Century Mine

RE: Response to Comments, Bennoc Area NPDES OIL00159 Application for American Energy Corporation in Belmont County, Ohio

Response to OEPA Comments from Bruce Goff and Eric Nygaard Dated 8/21/12, 8/15/12, 7/20/12, 7/13/12, and 7/11/12 Bennoc NPDES Permit Application OIL00159

Wheel treatment system – pictures provided by www.chemstream.com

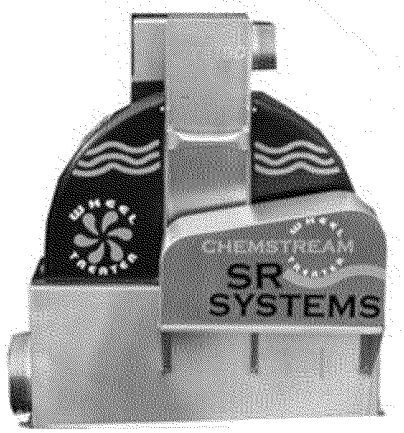
Comment: Do you happen to have any photos of the treatment ponds, the outlet structures, the chemical feed equipment and the discharge drainage ways (outlet ditches) you can share?

Response: We do not have any pictures of the proposed treatment ponds and their structures. However, we do have a picture (below) of the proposed wheel treatment system.

Section A'-A

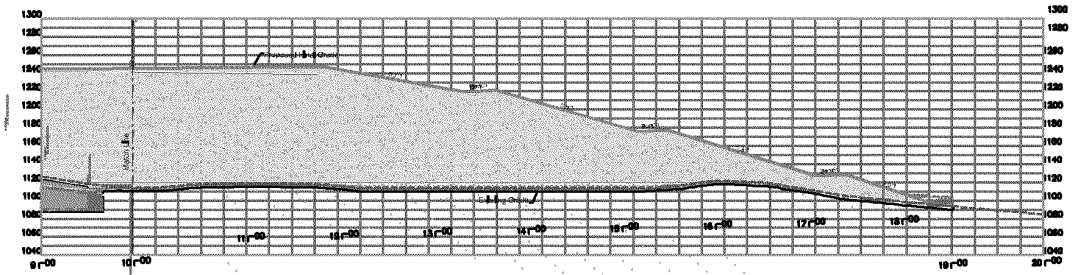
Comment: Also send us some typical cross sections of the refuse disposal area. Include a cross section before disposal of refuse, a cross section during disposal and a final cross section showing final grades and reclamation.

Response: Cross sections of the area for before disposal and after reclamation can be found in the attached drawing Sections A'-A & B'. During disposal cross-sections would be difficult to supply due to the constant change during construction.
